Supplemental Draft EIS Errata

3 Supplemental Draft EIS Errata

Table 3-1. Supplemental Draft EIS Errata

Section 3.16.2
(page 3-98)

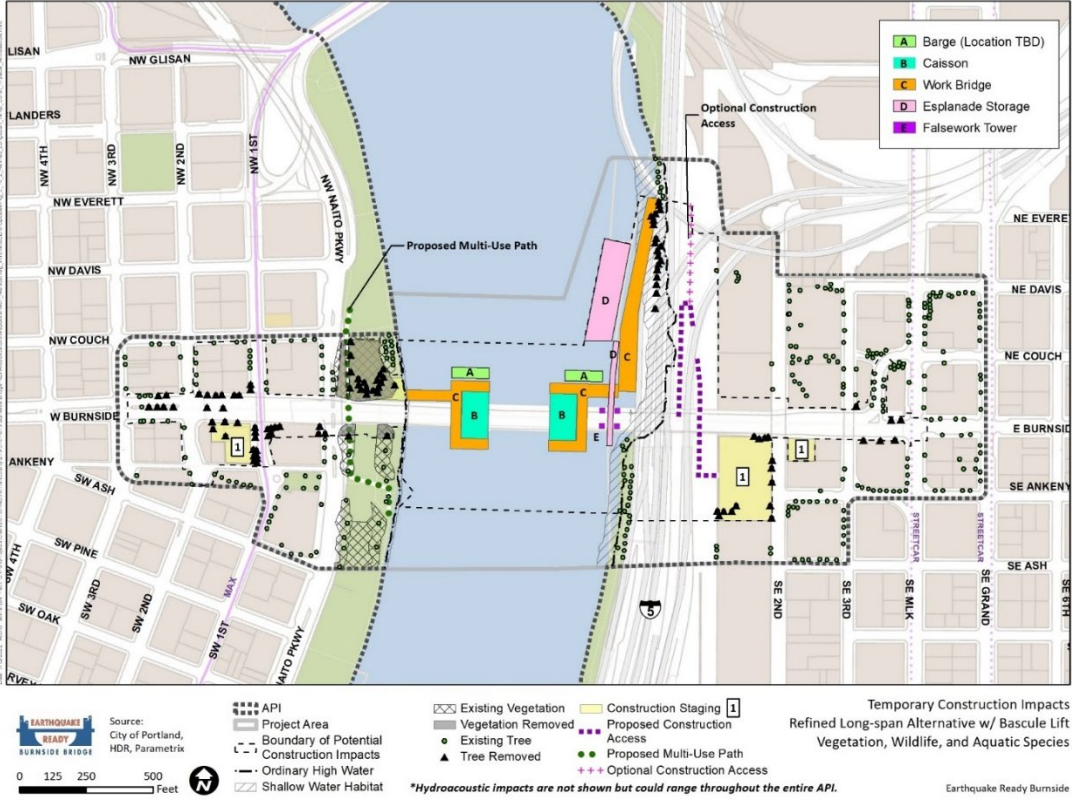
Revised to change the number of trees shown.

Section 3.16.2
(page 3-99)

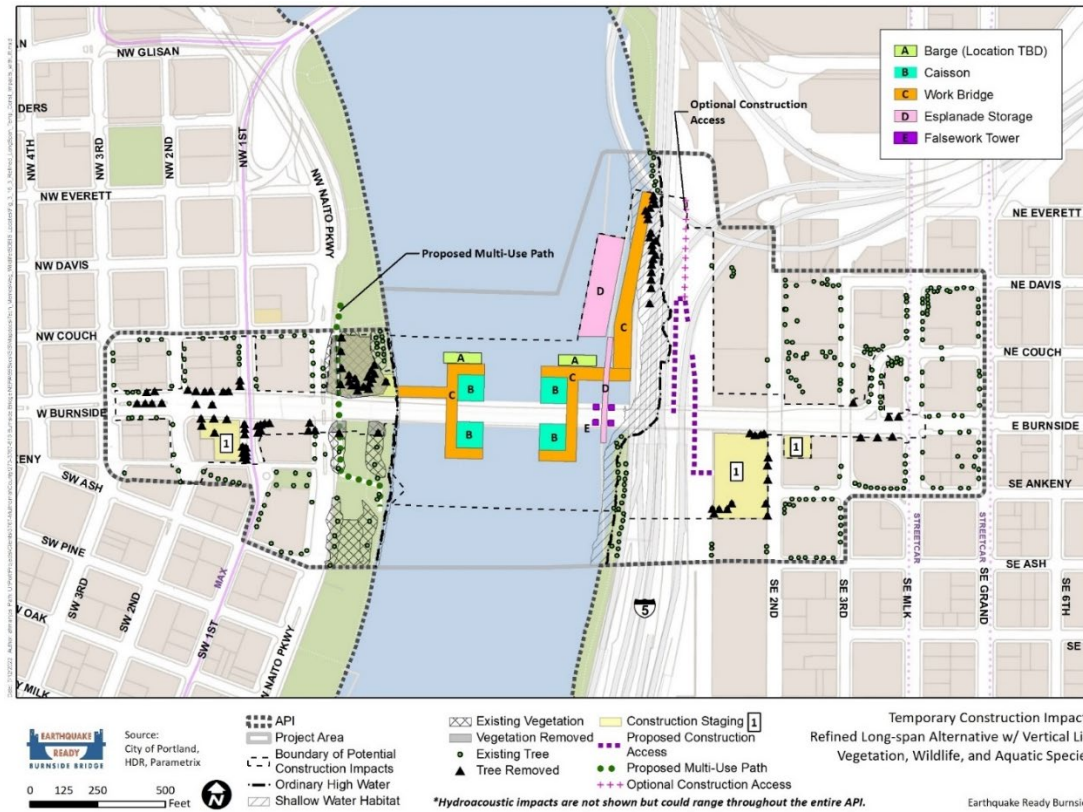
Revised to change the number of trees shown.

Section 3.16.2
(page 3-100)

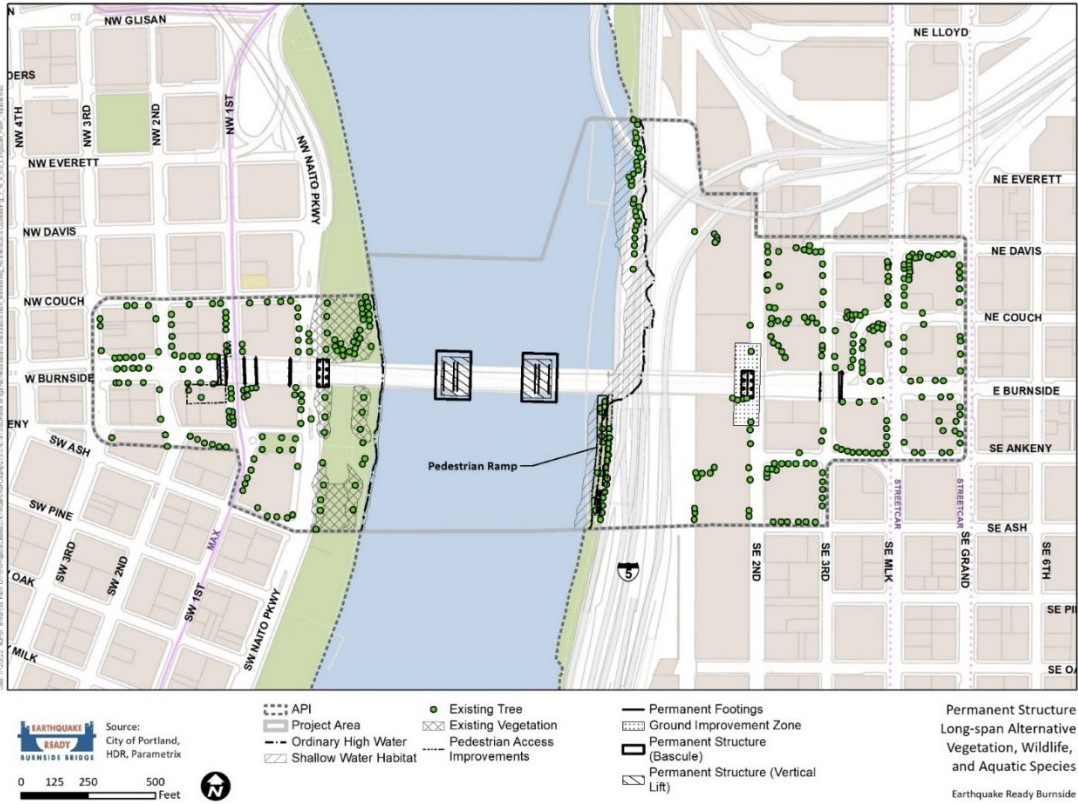
Revised to change the number of trees shown.

Section 3.16.2
(page 3-101)

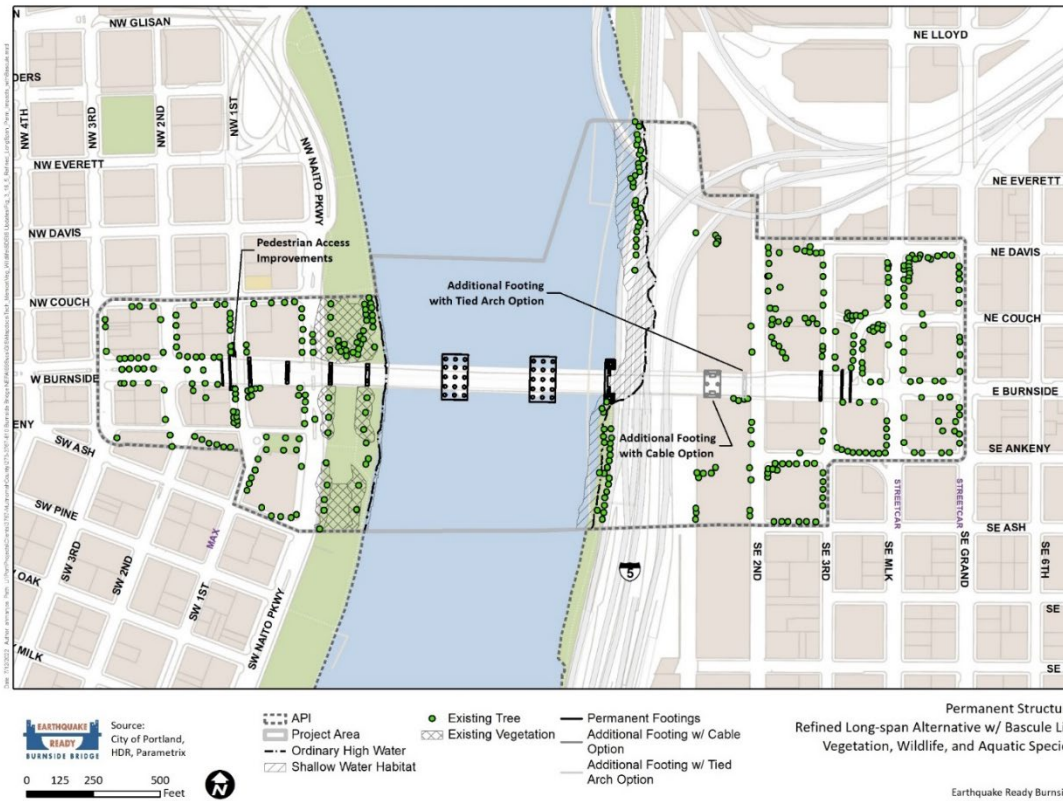
Revised to change the number of trees shown.

Section 3.16.2
(page 3-102)

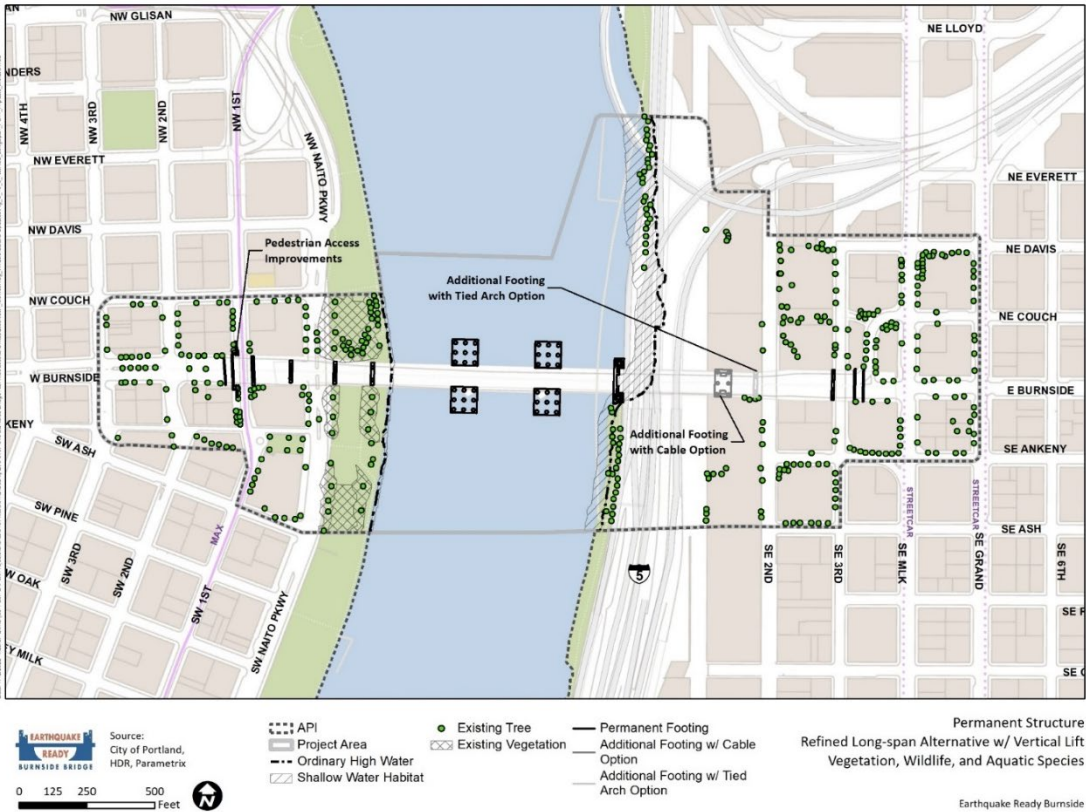
Revised to change the number of trees shown.
